Project Title: Priors & Pearce's Farm

Project No/ Document Reference: A218-R061

RESPONSE TO LLFA DRAINAGE COMMENTS ON FRA

SITE WIDE DRAINAGE CATCHMENT STRATEGY

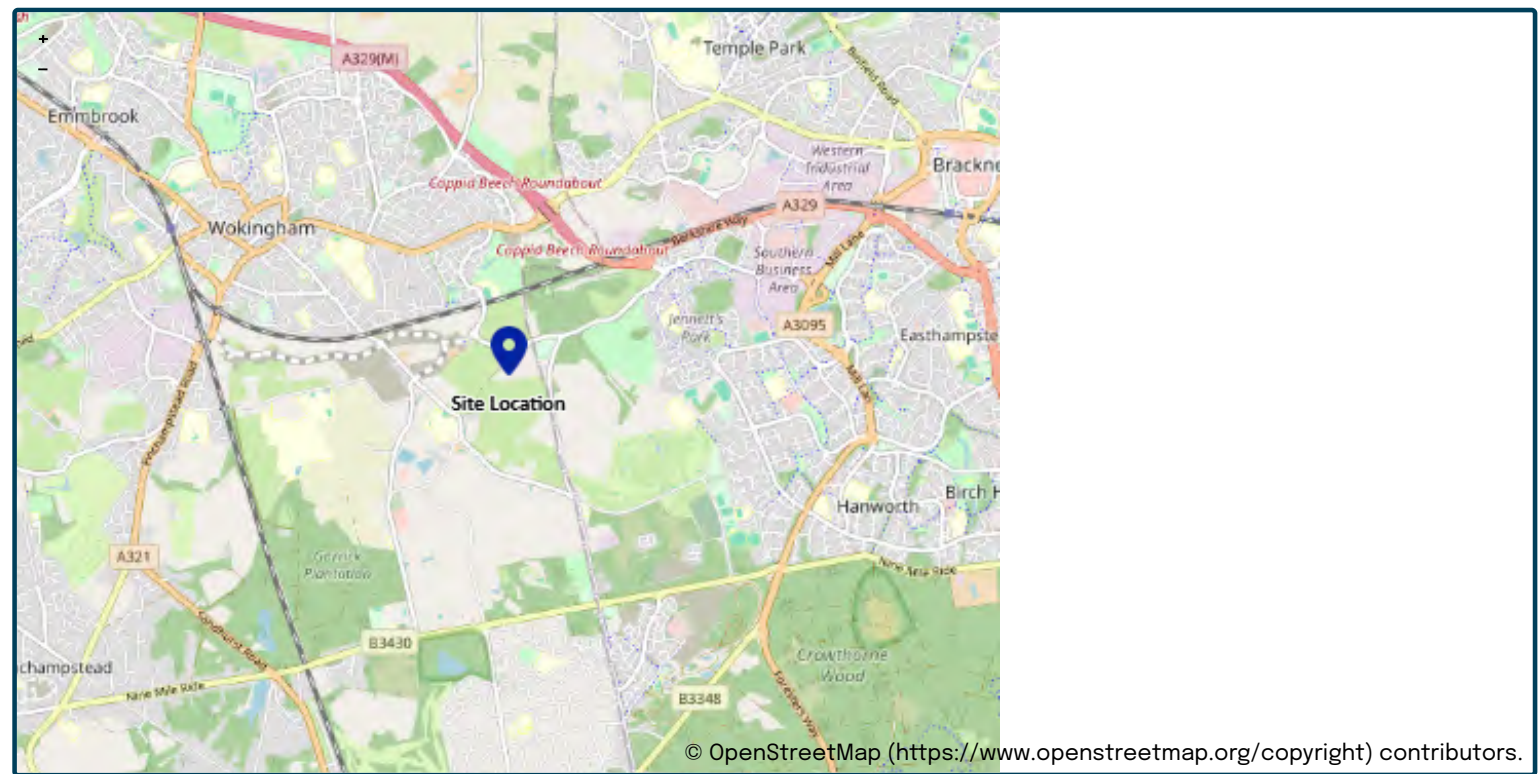
- outfall viability should be confirmed rather than assumed, with survey evidence of receiving watercourse invert levels, bank levels and cross-sectional capacity;

- confirmation is required that basin outfall invert levels are appropriately related to the 1 in 100 year plus 14% climate change fluvial flood level, particularly where basins are located close to the Flood Zone 2 / 3 corridor. Please refer to paragraph 7.2

- catchment boundaries shown on the outline drawing are indicative and will need to be updated as the detailed layout evolves;
- individual sub-catchment discharge rates will need to be checked at detailed design stage, particularly where rates may fall below the minimum practical discharge rate;

- distributed source control storage relied upon within the strategy should be spatially located at Reserved Matters stage;
- swales and filter drains should be supported by sizing calculations at detailed design stage;

- flow controls should be individually sized for each basin based on the confirmed contributing catchment area and discharge rate;
- basin cross-sections and volume / depth curves should be provided at Reserved Matters stage to confirm that the required storage volumes can be achieved within the available footprints; and

- groundwater monitoring information should be provided to confirm basin liner requirements.

- 7.3. The LLFA requested confirmation that basin outfall invert levels are appropriately related to the 1 in 100 year plus 14% climate change fluvial flood level in the receiving watercourse.

- 4.1. The revised site-wide drainage catchment strategy is shown on drawing A218-025 P7, titled "Site Wide Drainage Catchment Strategy", dated May 2026.

- 4.2. Revision P7 notes that the flow route and catchments have been amended to suit basin updates. The drawing continues to show the application boundary, proposed developable area, drainage catchment areas, proposed attenuation basins, basin outfalls, swale / filter drain corridors, natural overland flow routes and the Flood Zone 100 year plus 14% climate change extent.

- 7.4. The revised drawing shows the Flood Zone 100 year plus 14% climate change extent in relation to the proposed drainage catchments, attenuation basins and outfalls. Furthermore, the drawing shows the anticipated outfall location and the modelled flood level at these locations within the table. The basins have been raised to ensure their base is above the flood level at these locations. It is, however, this point that conflicts with other elements of WBC objectives as well as providing a scheme that may not be aesthetically pleasing and/or require extensive earthworks. We therefore request WBC to reconsider this request.

- 7.5. Abley Letchford appreciates the drainage need to raise basin levels above any flood level but this contradicts with WBC landscape objectives of having SuDS features that are in keeping with the existing landform and not overly engineered. The definition of a flood level is that it is at ground level. In the case of Priors Farm this

- 7.8. We appreciate the need to ensure the drainage scheme works in all storms but we request the outfalls are above another datum, such as the 1 in 10 year flood event or top of bank, with sensitivity testing undertaken on a surcharged outfall for the storms in excess of this up to the 1 in 100 year flood event plus 14% climate change. This means the basins will work as intended for the majority of storms throughout the year but for the most extreme events the basins will maintain the flood levels and act as storage the same as they would if raised out of the ground. This is easily achieved with a non-return valve within the system which is normal construction and flood modelling detailing.

- 7.9. Notwithstanding the above to clarify, at outline stage, the strategy remains based on providing attenuation storage outside the main developable areas, with controlled discharges to the receiving drainage network. Final outfall levels, headwall arrangements, non-return protection where required, and any interaction with fluvial flood levels will be confirmed through detailed design.

P7	05/26	Flow route and catchments amended to suit basin updates	DZ	JS
P6	03/26	Basins 1 & 2 updated	DZ	JS
P5	07/24	Layout updated to latest version	LC	JS
P4	07/24	Discharge Points added	LC	JS
P3	03/24	Basins 1 & 2 updated	LC	JS
P2	01/24	Swales/filter drain added showing basin connections.	LC	JS
P1	12/23	First Issue	LC	JS
Rev	Date	Description	Drawn	Checked
